## Niagara Park Station Upgrade

# **Niagara Park Station Upgrade – Determination Report**

**Ref – 6472234**

**Figure 3 Revised key features of the Proposed Activity (indicative only, subject to detailed design)**

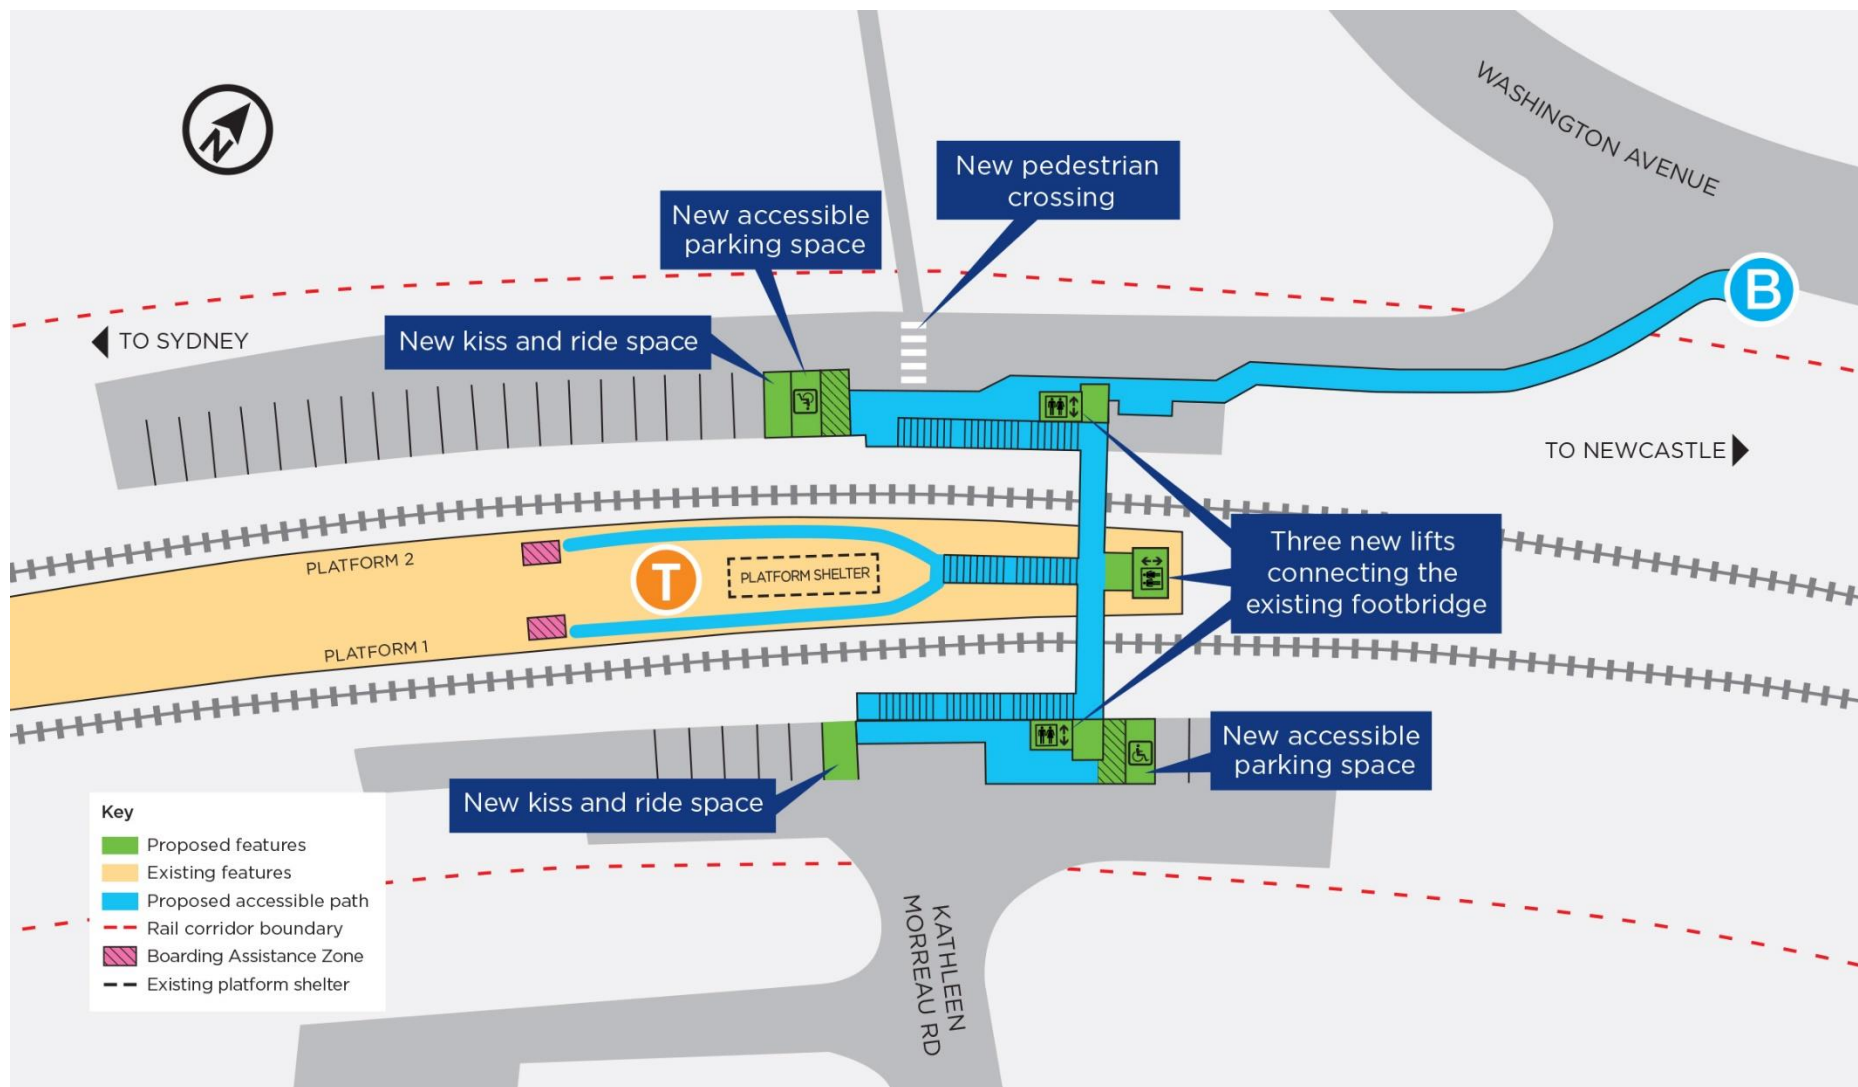
Further design development, along with consultation with the community and stakeholders, has resulted in a change to the Proposed Activity described in the Niagara Park REF. This change is outlined in Table 3, along with a discussion of the impacts, and shown in Figure 3.

Aspect of the Proposed Activity	Design change	Discussion of impacts
BAZ canopy	The proposed freestanding canopy over the Boarding Assistance Zone (BAZ) has been removed from scope. The additional BAZ canopy was a desirable item but not required for DDA or DSAPT compliance and by locating the BAZ's close to the existing canopy we can meet the TfNSW directive to have a canopy within proximity to the BAZ.	The proposed removal of the BAZ canopy from scope would not introduce additional environmental impacts. The change is expected to reduce the visual impacts identified in the REF and the Landscape Character and Visual Impact Assessment (Envisage, 2020). The modification would reduce visual clutter on the Platform and would avoid the addition of a new structure into key viewpoints.

Since the public display of the REF there has been a change to the proposed design, the proposed freestanding canopy over the Boarding Assistance Zone (BAZ) has been removed from scope. The additional BAZ canopy was a desirable item but not required for compliance with the *Disability Discrimination Act 1992* or the *Disability Standards for Accessible Public Transport 2002* and by locating the BAZ's close to the existing canopy we can meet the TfNSW directive to have a canopy within proximity to the BAZ.
